# LaSalle UHS Temperature Limit Modification Request -- TAC MD0336 / 7

## Measurement uncertainty review and alternative calculation

- "Calculation" refers to licensee calculation L-003230 revision 000, transmitted via letter RS-06-106, (August 4, 2006)
- Prefixes "c" and "a" indicate licensee and alternative values, respectively

**Appendix: Verification of RTD Temperature/Resistance Factor**

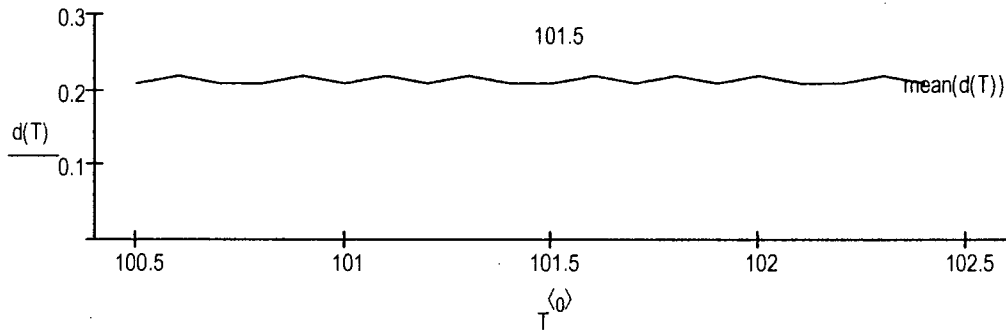
Calculation ref 5.4.1 lists the resistance temperature coefficient as  $0.00385 \Omega/\Omega/C$ :  $R_t := 0.00385 \cdot T_{10,1} \cdot C \quad R_t = 0.2460$

The discrepancy between the quoted value and the data is:  $\frac{R_t - \text{mean}(d(T))}{\text{mean}(d(T))} = 14.9533\%$

Calculation ref 5.4.1 lists repeatability as 0.2F, but ref 5.4.3 lists accuracy as 0.06% at 0C. The ref 5.4.3 specification results in a net accuracy estimate of:

This discrepancy may be due to differing definitions of "accuracy" and "repeatability" and so is not addressed in the alternative calculation.
